Docket No. 52-021
MHI Ref: UAP-HF-09488

Subject: MHI's Responses to US-APWR DCD RAI No. 459-3331

Reference: 1) "Request for Additional Information No. 459-3331 Revision 1, SRP Section: 03.06.02 – Determination of Rupture Locations and Dynamic Effects Associated with the Postulated Rupture of Piping, Application Section: 3.6.2," dated 9/16/2009.

Responses to Request for Additional Information No. 459-3331,
Revision 1

Figure 1 CVCS Piping Penetration Area

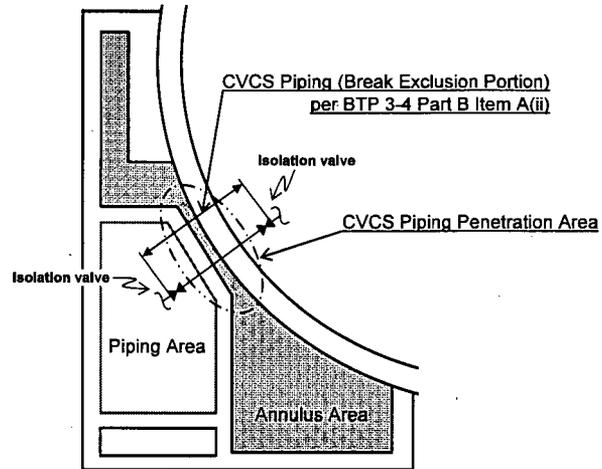
In its response to RAI 03.06.02-8, MHI stated that since the PCCV penetrations are isolated in compartments made of concrete, guard pipes are not considered necessary around the PCCV penetrations. Therefore, it is not considered necessary to apply criteria of guard pipe, BTP 3-4 Part B Item A(ii)(3) and A(ii)(6) for this room. However, it appears to the staff that the guard pipe assembly is functionally similar to the piping penetration compartment (or sleeve) indicated in the DCD and MHI did not address the staff's concern described in the original RAI. Therefore, the applicant is requested to clarify whether conditions specified in BTP 3-4, Part B, Items A(ii)(3) and (6) are applicable to the design of piping penetrations shown in DCD Figure 3.8.1-8 or provide the design criteria for these piping penetrations.

The annulus area is composed of several closed compartments surrounding the prestressed concrete containment vessel (PCCV). The high energy piping penetrating the PCCV is main steam, feedwater, steam generator blowdown, and chemical and volume control system (CVCS) piping. The high energy piping runs from the PCCV through the annulus to the piping area, which is isolated in a compartment made of concrete, is shown in Figure 1. The high energy piping has an isolation valve in the piping area. Therefore, the portion of the high energy piping passing through the annulus is not necessary to postulate pipe break due to satisfying pipe break exclusion criteria specified by BTP 3-4 Part B Item A(ii). Specifically, this portion passing through this area is designed with stress limitation, no weld attachment, minimization of welding, and 100% volumetric in-service examination is carried out for welding. Therefore guard pipes are not considered necessary for high energy piping penetrating the PCCV.

The moderate energy piping is also passing through the annulus. The postulated leakage crack of the moderate energy piping will not cause significant pressurization. Therefore, guard pipes are also not considered necessary for moderate energy piping penetrating PCCV.
